Amendments to the Drawings:

This Amendment and Response is in reply to the Office Action mailed January 16, 2007. A one (1) month extension of time is filed herewith. Therefore, the time period for reply extends up to and includes May 16, 2007.

Inventor: Brown et al.
Docket No.: 08436.0073USC1
Title: Improvements To Mechanical Composting
Serial No.: 10/639,947
Annotated Sheet 1 of 1

Figure 1.

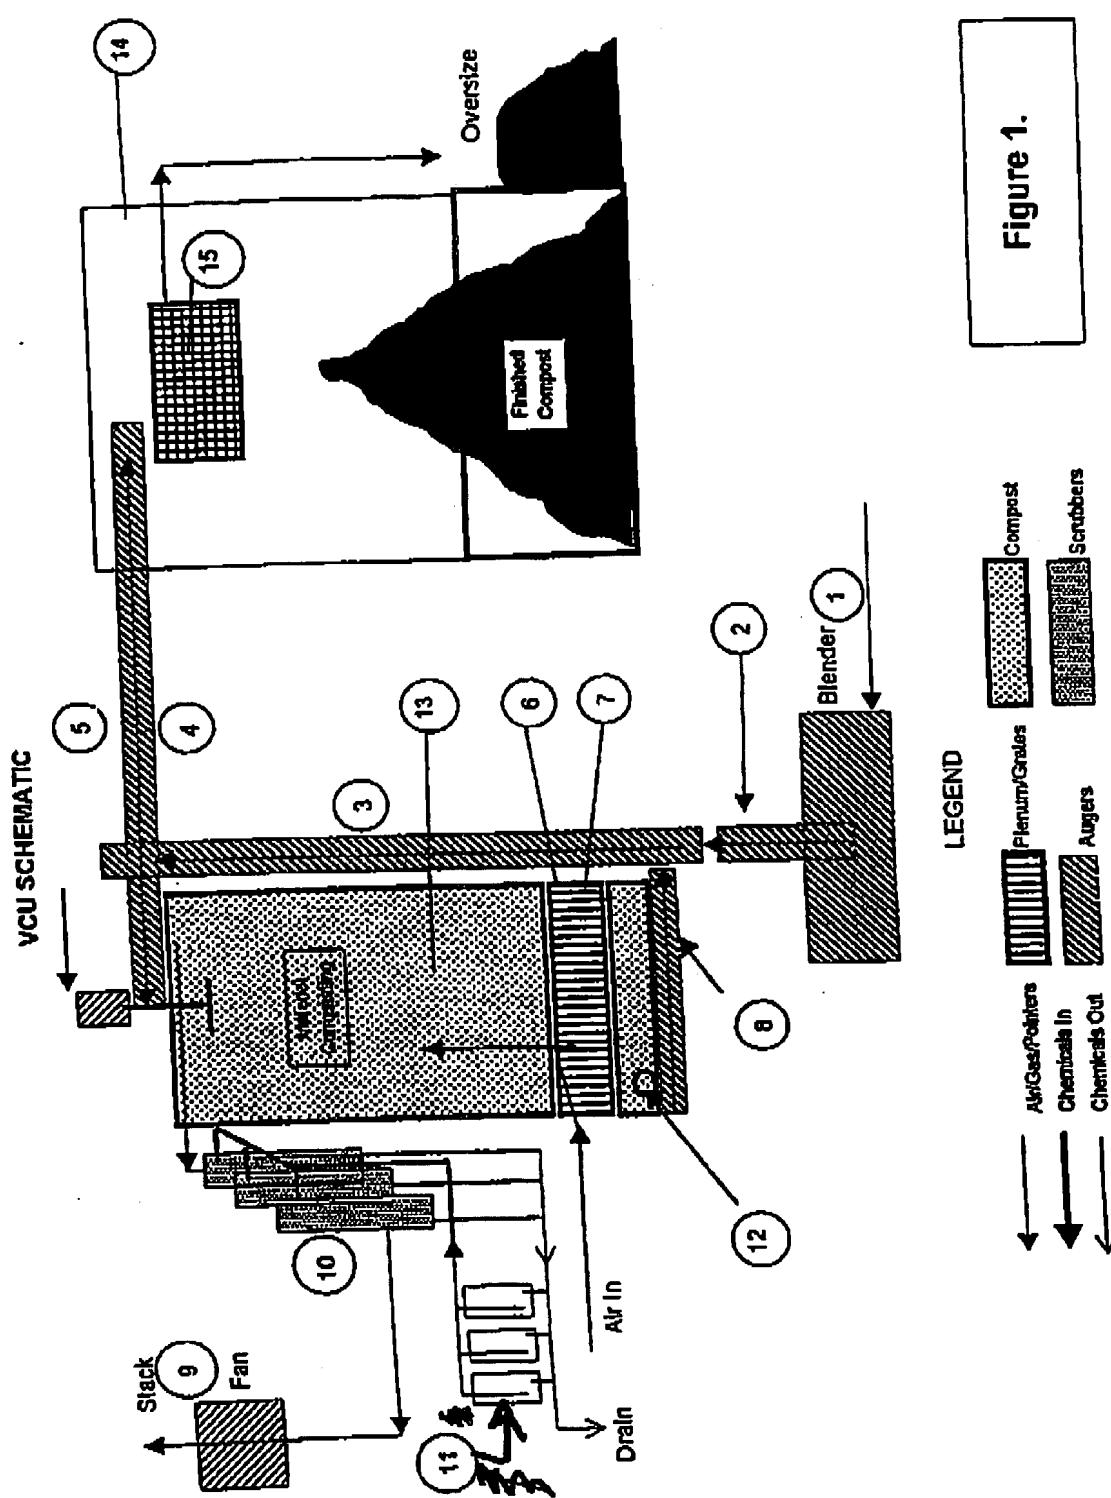
The designation 11 has been amended to point at the tanks discussed at page 11, lines 21-26.

In the Action, the Examiner first objected to the drawings because numeral 11 has two arrows. Applicants have enclosed herewith an annotated Figure 1 and a replacement sheet. In the replacement sheet, it has been clarified that the designation 11 points to the tanks (discussed at page 11, lines 21-26). Applicants respectfully request the Examiner's reconsideration and withdrawal of the objection.

The attached drawing sheet reflects the change to Figure 1.
